Door control TS 971 – Discontinuation of second UBS socket

Figure

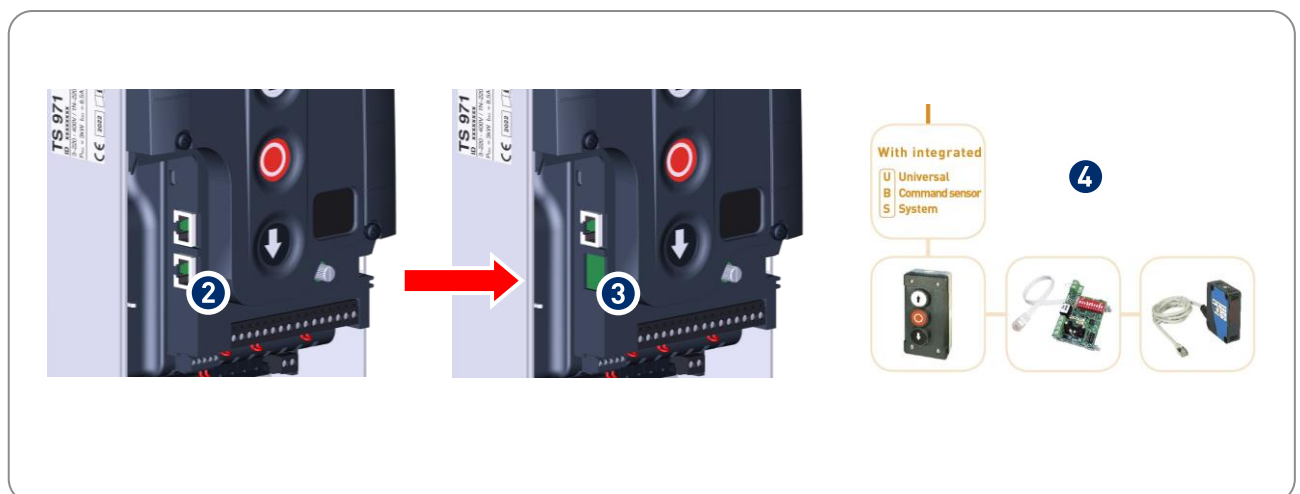
In preparation for the new, modern data interface, for the door control TS 971 (❶), the second UBS¹⁾ socket (❷) is discontinued.

To this end, the TS 971 will have only one UBS socket (❸) as is currently the case already with the door control TS 970. The UBS system can continue to be used as usual with electric UBS components such as control devices, loop detectors or photo cells.

- The changeover will take place starting 05/2022.
- Mixed deliveries may happen due to inventories.
